**CITY PLAN COMMISSION****THURSDAY, JUNE 25, 2026****FILE NUMBER:** PLAT-26-000149**SENIOR PLANNER:** Sharmila Shrestha**LOCATION:** at the terminus of Wild Honey Drive, south of Tioga Street**DATE FILED:** June 1, 2026**ZONING:** R-5(A)**CITY COUNCIL DISTRICT:** 8**SIZE OF REQUEST:** 6.01-acres**APPLICANT/OWNER:** Mammaya Enterprise, LLC

**REQUEST:** An application to create a 53-lot Small Lots SB15 development ranging in size from 3,000 square feet to 3,391 square feet and 5 common areas from a 6.01-acre tract of land in City Block 8292 on property located at the terminus of Wild Honey Drive, south of Tioga Street.

CITY PLAN FILE NO. PLAT-26-000149  
PRELIMINARY PLAT  
FOR

### TIOGA ADDITION

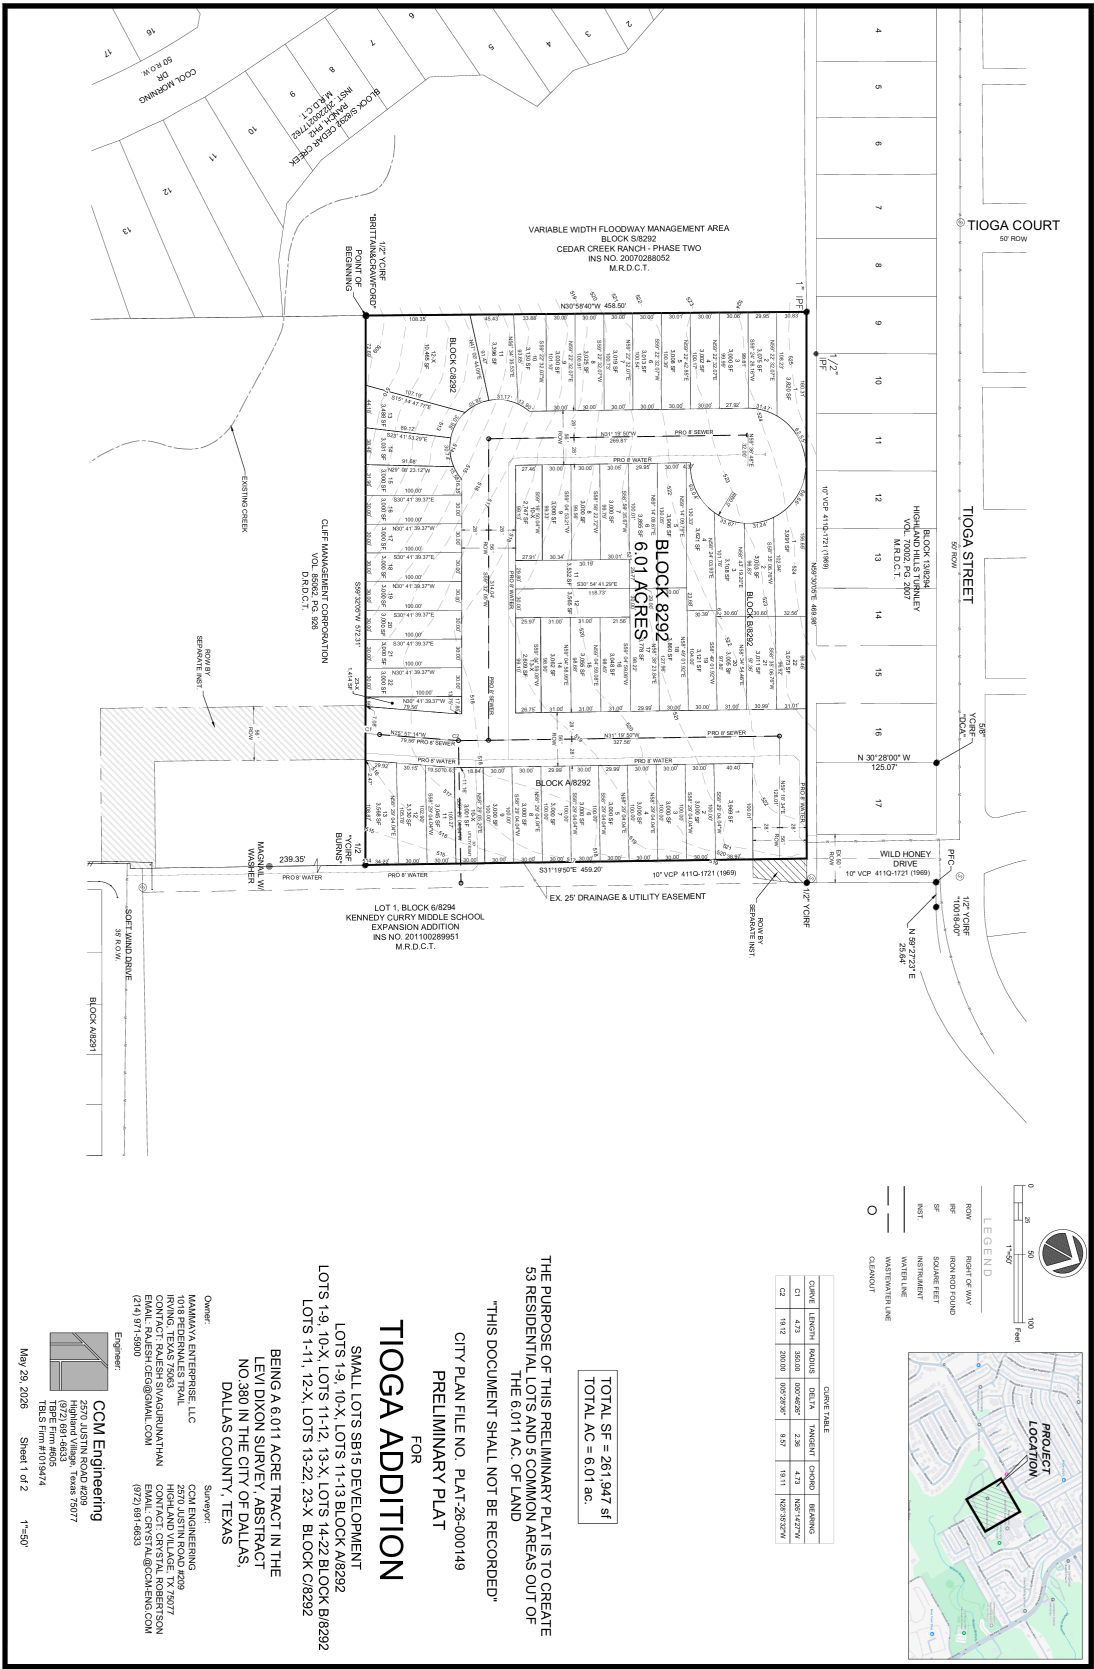
27. Prior to the final plat, Real Estate release is required.
28. On the final plat, label "Tioga Circle."
29. On the final plat, change "Cool Morning Drive" to "Cool Morn Drive."
30. On the final plat, identify the property as Lots 1 through 21 and Common Areas A and B in City Block 1/8292, Lots 1 through 18 and Common Areas C and D in City Block 2/8292, Lots 1 through 12 and Common Area E in City Block 3/8292.
